## **CABINET MEMBER FOR ENVIRONMENT – 17 DECEMBER 2020**

### **CUMNOR – OXFORD ROAD: PROPOSED 30MPH SPEED LIMIT**

**Report by Interim Director of Community Operations**

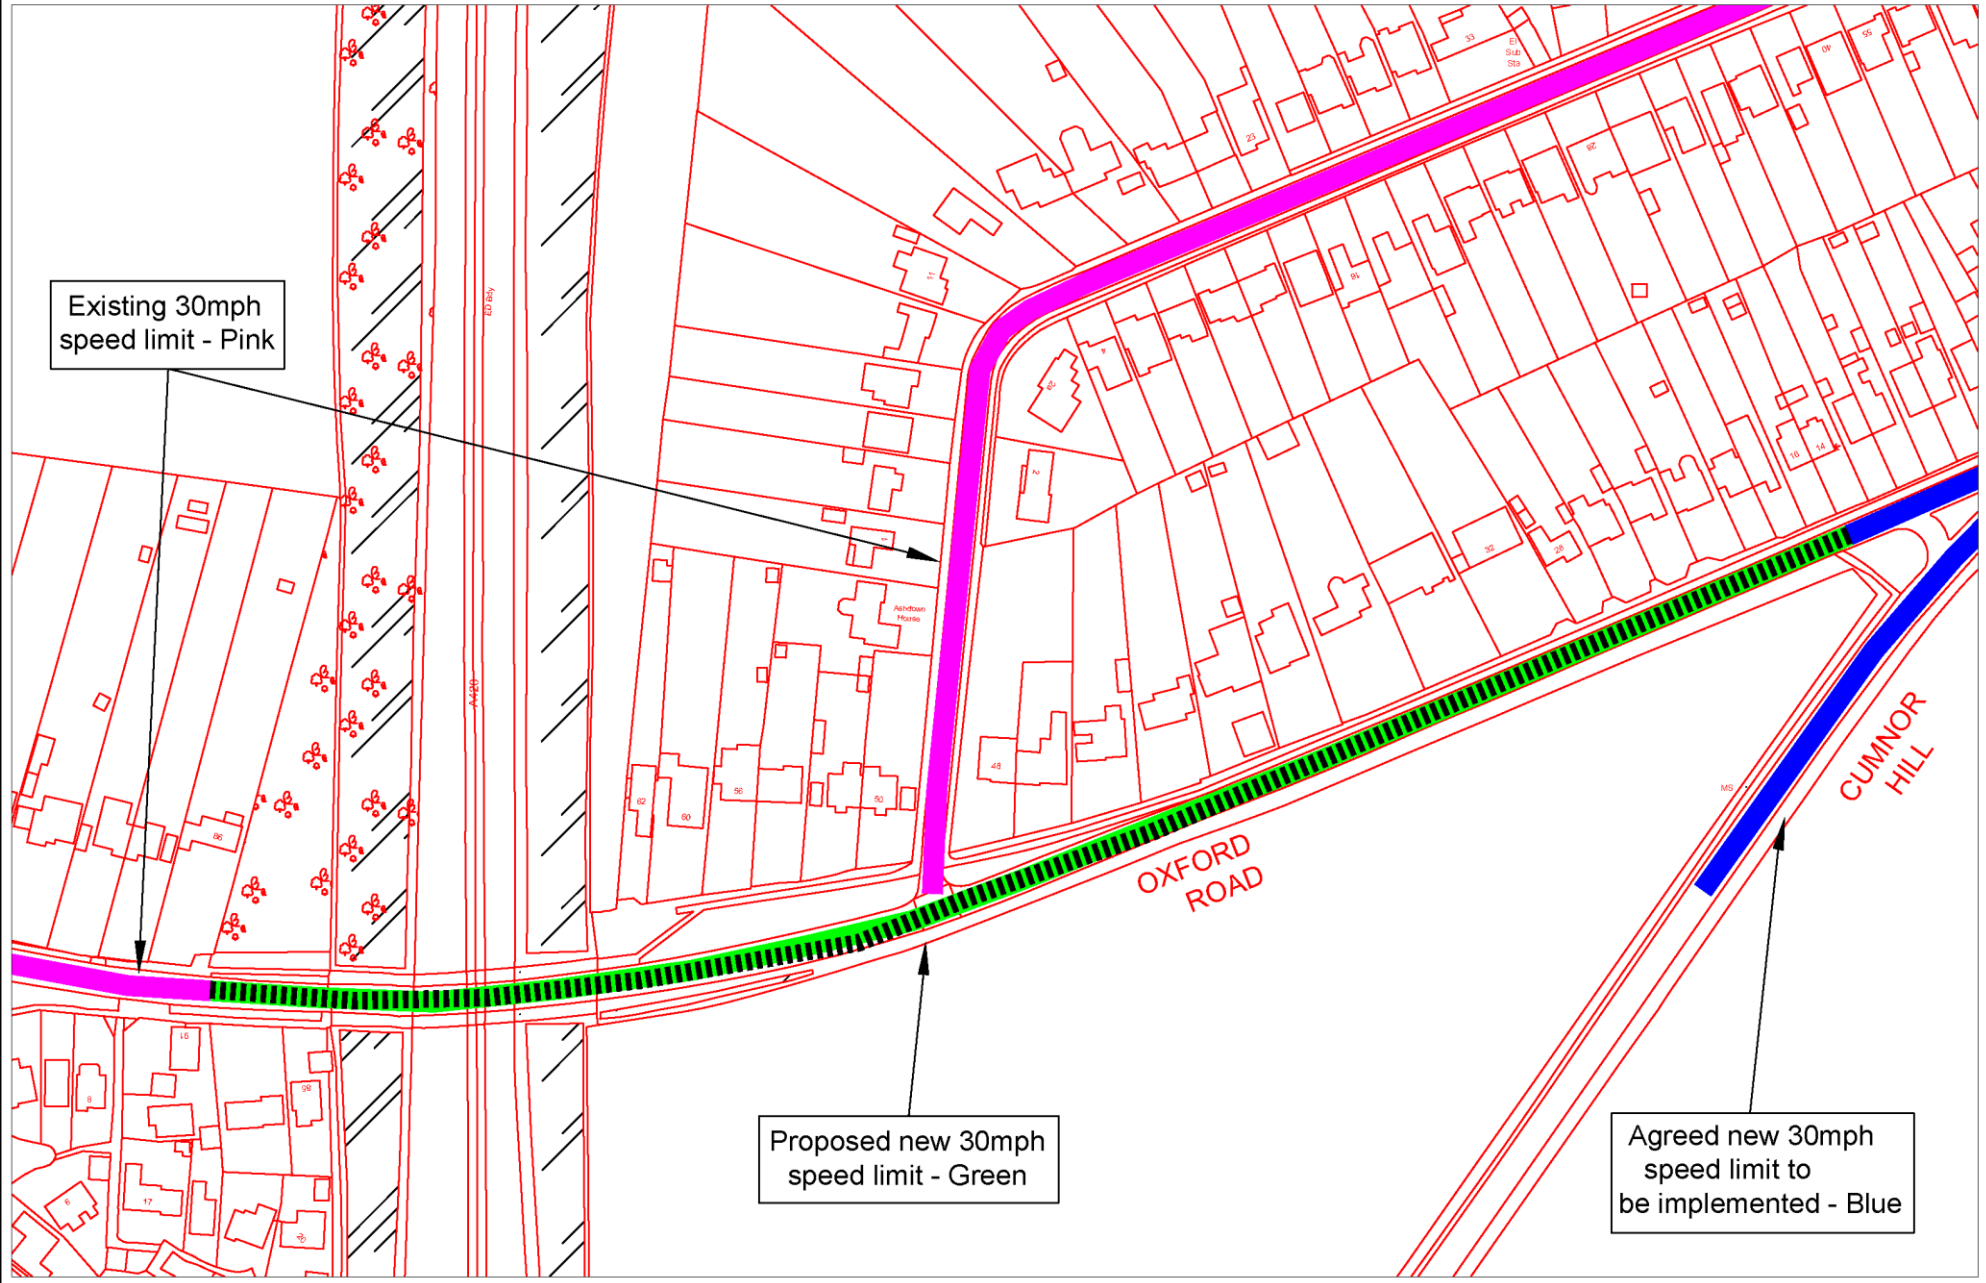
| RESPONDENT   | COMMENTS   |
|--|--|
| (1) Traffic Management Officer, (Thames Valley Police) | <p><b>Concerns</b> – In principle based of the results of the speed survey I do not object. Mean speed data would suggest 30 is acceptable.</p> <p>I do however raise concern. I do not believe joining the village of Cumnor 30 and Cumnor Hill 30 is best practice. This method is likely to lead to drivers paying less respect to both limits. Cumnor Hill speed limit has been the subject to complaint for a number of years and making this whole area a 30 it is unlikely to change that.</p> <p>Further measures may need to be included in the future as any targeted enforcement also unlikely.</p>                   |
| (3) Local Resident, (Cumnor)                           | <b>Object</b> - Why's it needed? Stop changing things when there's no reason.  |
| (4) Local Resident, (Cumnor)                           | <b>Object</b> - My husband and I do not agree with the 30mph limit on the hill. We believe it is a knee jerk reaction to a child who was injured by not following the 'green cross' code. There are many cyclists going up and down the hill and it requires a careful burst of speed to overtake them when there is no oncoming traffic otherwise traffic is limited to 20mph. We use this route, sometimes, several times a day and we don't experience drivers exceeding the present limit. Buses, work vehicles, homeowners turning in and out of roads up and down the hill and road works tend to slow all traffic anyway. |
| (5) Local Resident, (Cumnor)                           | <b>Concerns</b> - I would be glad to support this, but in the earlier Cumnor Hill consultation we were advised it would be useful to keep a small section here at 40 in order to have a 30-gateway entering the village at the Glebe. So in the event of a driver becoming complacent of a speed limit set at the station, there would be a proper reminder at the village, at the sharp left (chevrons sign fell off a year ago), where school children merge from all directions.  |

| <p>(6) Local Resident,<br/>(Wootton)</p> | <p><b>Concerns</b> - My concern is that the Council keep looking to reduce speed limits on roads, often without any clear evidence and justification that speed is a real safety issue.</p> <p>To keep the car-driving public on side and retain some credibility (as a balanced decision-making body), taking the easy option of reducing speed limits everywhere, can be counterproductive - especially where there is little justification.</p> <p>Please use your powers appropriately and not take the 'easy option' every time a vocal minority call for speeds to drop further.</p> |

8. Thames Valley Police did not object but expressed a view that they do not believe joining the village of Cumnor 30mph limit and Cumnor Hill 30mph limit represented best practice and was likely to lead to drivers paying less respect to both limits. Cumnor Hill speed limit has been the subject of complaint for a number of years and making this whole area a 30mph limit was unlikely to change that.

12. While noting the above responses it is considered that the proposal is consistent with national advice on setting local speed limits.
13. Twenty-seven responses of support were received from members of the public.
